North Hertfordshire District Council

Building Conservation comments

File Ref: 20/00643/LBC

Subject: Internal and external alterations to Barn, East Stables and West Stables. Single storey link extension between Farmhouse and East Stables and between East Stables and Barn and single storey extension to front (east side) of West Stables.

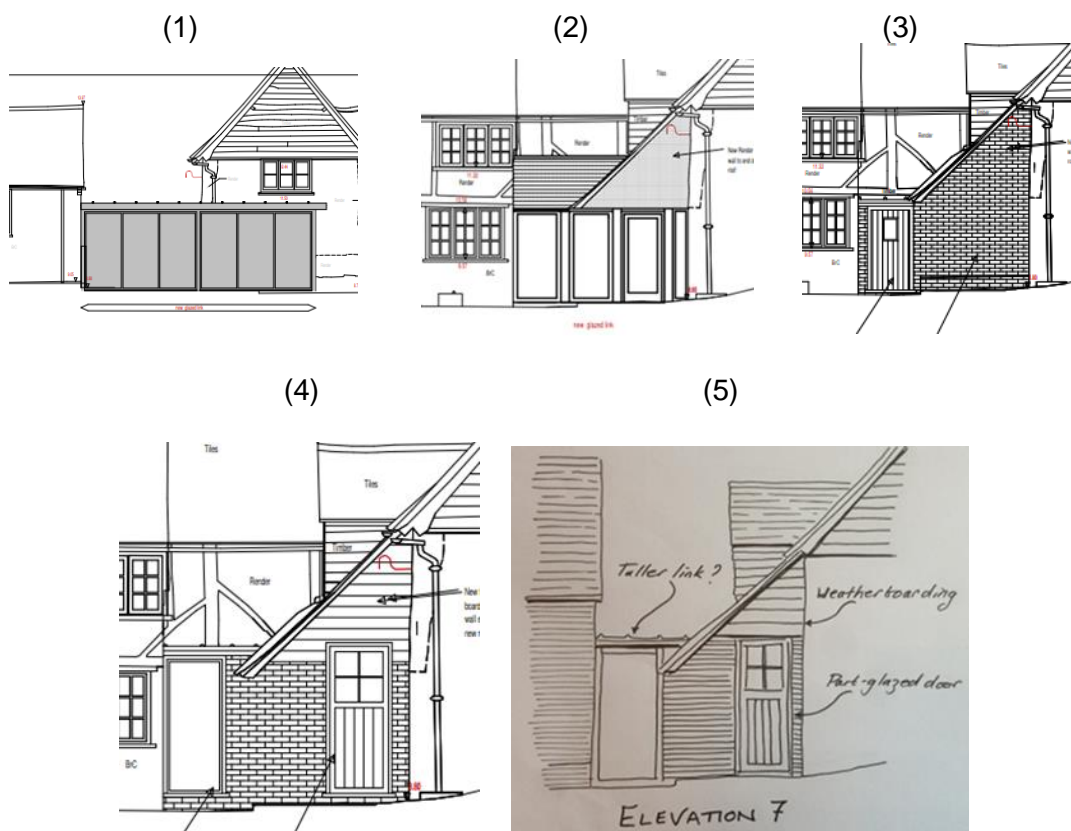
- 2.1 The images below show the progression of the discussion from the initial flat roof, large glazed 'box' concept (1) through to a partially glazed lean-to with dual-pitched link (2), through to a brick lean-to with flat roof link with solid doors (3) through to the current version of a part brick/part weatherboard lean-to with a short flat-roof glazed link (4).

- 2.2 Whilst there would be a modest amount of harm occasioned to the farmhouse and to the East Stables by forming this link, this element is crucial to the accessibility of this courtyard group. The latest version follows the format offered in a sketch I prepared previously (see 5 above) and I am prepared to support this alteration.

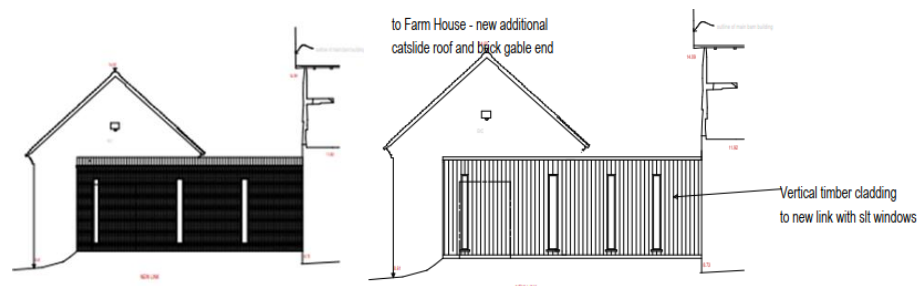
- 3.2 It has, therefore, not yet been established as to the extent of any necessary roofing repairs.
- 3.3 I note that the elevation treatment has been amended from the top image below to the bottom image below and is now considered to be a much more sensitive handling of the elevation and is unobjectionable.

- 5.4 Included with the latest submission is a new drawing no. REF-MNP-WSC-SK-S-4011 Rev P1 entitled West Stable – Centre East Elevation – External Timber Repairs which was received on 21/01/2021. This drawing is really helpful in fully understanding the task in hand in bringing one elevation of one

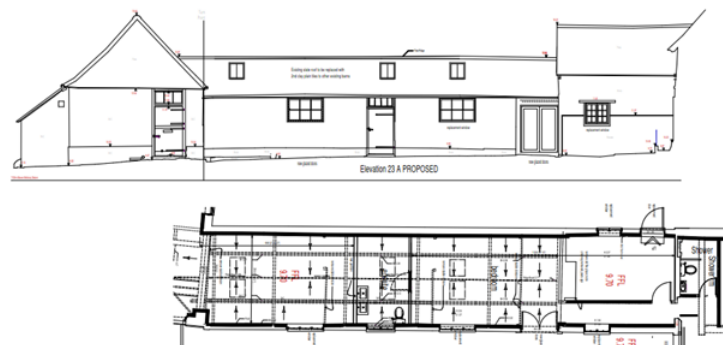
building up to an appropriate structural standard. This is an approach that is expected of the main barn also.
